**PCN# : P57SAAB**  
**Issue Date : Aug. 07, 2015**

**Information Only Notification**

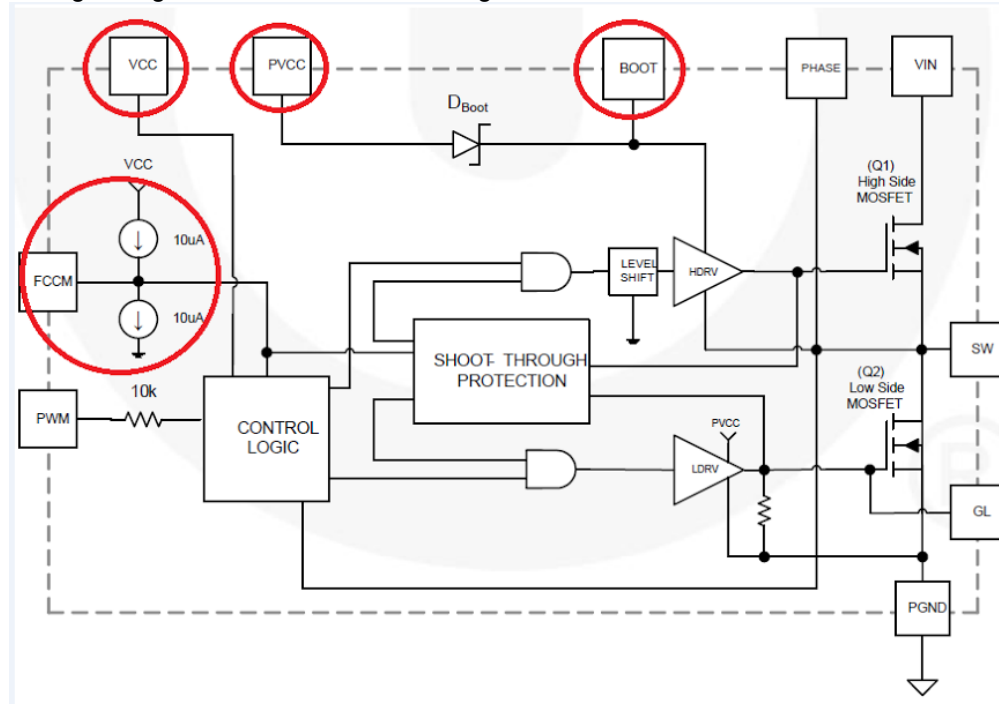
1. "Features" section on page 1, second bullet states "Compatible with Intersil IMVP-8 PWM Controller"
2. "Electrical Characteristics" table on page 5 - ICC\_SD spec value typ. 3uA / max 10uA
3. "Features" section in page 1, bullet "Low Shutdown Current: Ivcc < 3 uA"
4. Page 2, figure 1 Typical Application Diagram

1. "Features" section on page 1, remove second bullet "Compatible with Intersil IMVP-8 PWM Controller"
2. "Electrical Characteristics" table on page 5 - ICC\_SD spec value typ. 6uA / max. 11uA
3. "Features" section in page 1, bullet "Low Shutdown Current: I<sub>VCC</sub> < 6 uA
4. Page 2, figure 1 Typical Application Diagram updated to replace AGND symbol on C<sub>PVCC</sub> and the PGND symbol, swap PWM and FCCM pin locations and removed FCCM & PWM signal drawing examples.

1. In features section on page 1, the description of "Compatible with Intersil IMVP-8 PWM Controller" is removed due to repeated feature description with 1st sentence.
2. The ICC-SD spec. value is updated based on char. test data.
3. The I<sub>VCC</sub> spec value is updated based on char test data
4. and 5. - Figure 1 and figure 2 diagrams are being updated for format and reflect Gnd references correctly.
